# City of Santa Barbara California

## PLANNING COMMISSION STAFF REPORT

**REPORT DATE:** August 31, 2007  
**AGENDA DATE:** September 13, 2007  
**PROJECT ADDRESS:** 927 & 933 Olive Street (MST2006-000421)

A2.1

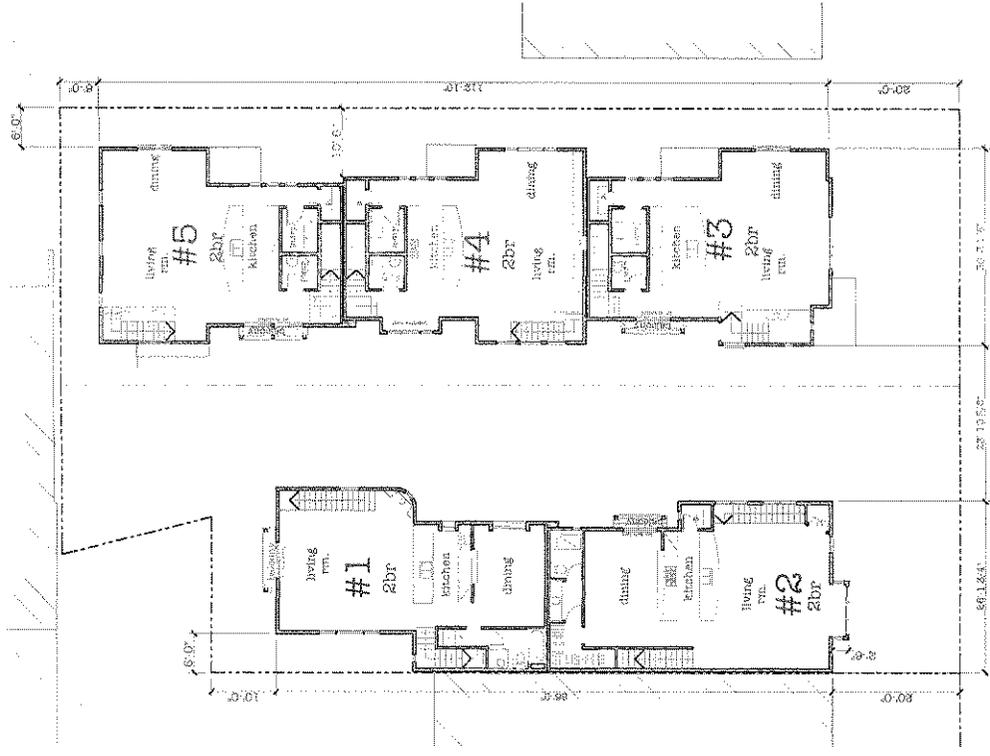
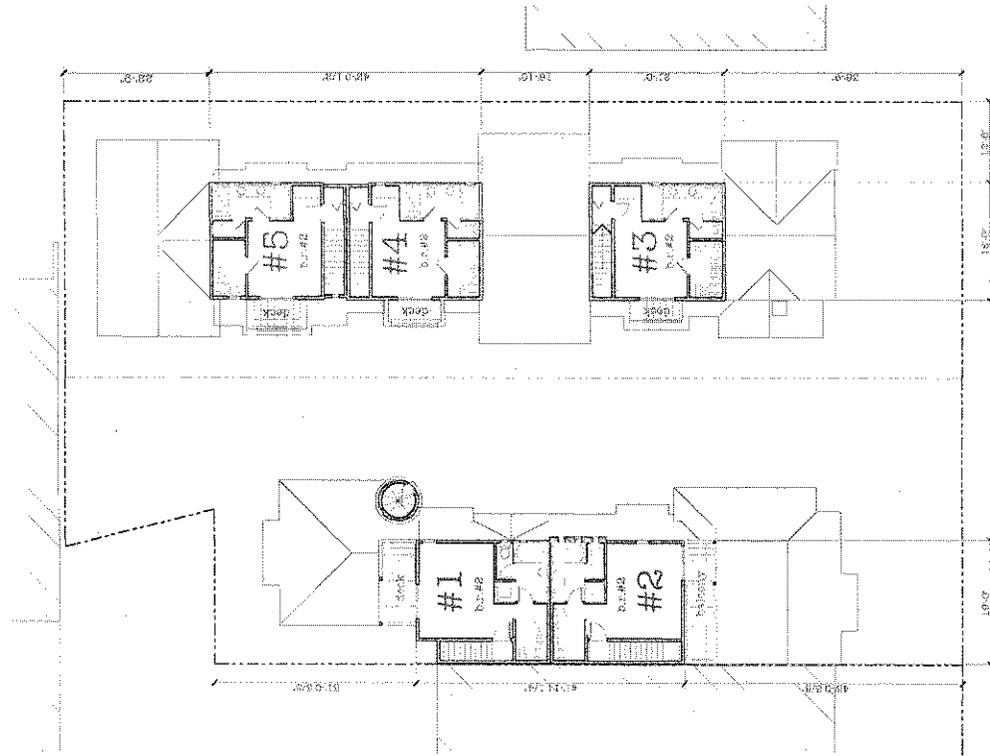
7. Show on the plans how the physical standards for condominiums, as required per SBMC §27.13.060, would be met. Please show the individual utility metering, private storage space, laundry area, and private outdoor living space as required per this section of the code.

**Applicant Response:** Individual metering is shown on the Preliminary Site Grading and Utility Plan, private open space and storage space is shown on the Site Plan, sheet A1.0. Laundry areas are shown on the First and Second Floor Plans Sheets, A1.1 & A2.1, respectively.

927 & 933 Olive St.  
 RESIDENCES  
 Santa Barbara, California  
 Syncom Homes of  
 California  
 Drawing:  
 EXTERIOR  
 ELEVATIONS

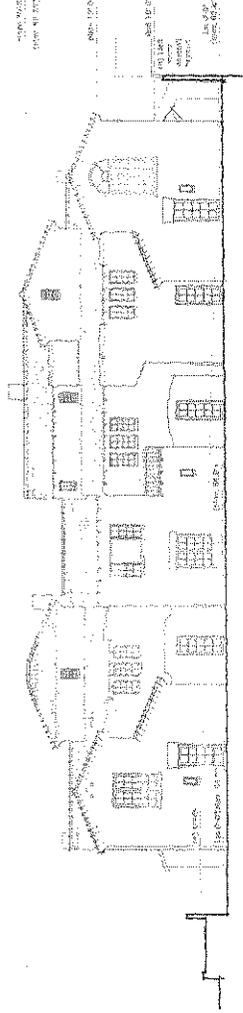
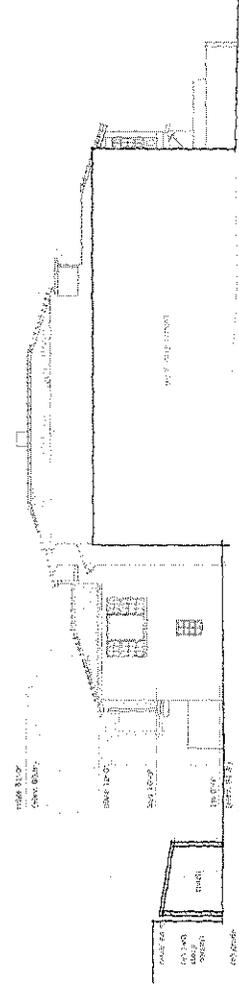
4. Correct the elevations to show the 18" pop out at the kitchen @ the west & east elevations.

5. Correct the west elevation to show the bathroom windows.

**Applicant Response:** Comment no longer applies as "pop out" has been deleted.

**Applicant Response:** Comment no longer applies with new configuration.
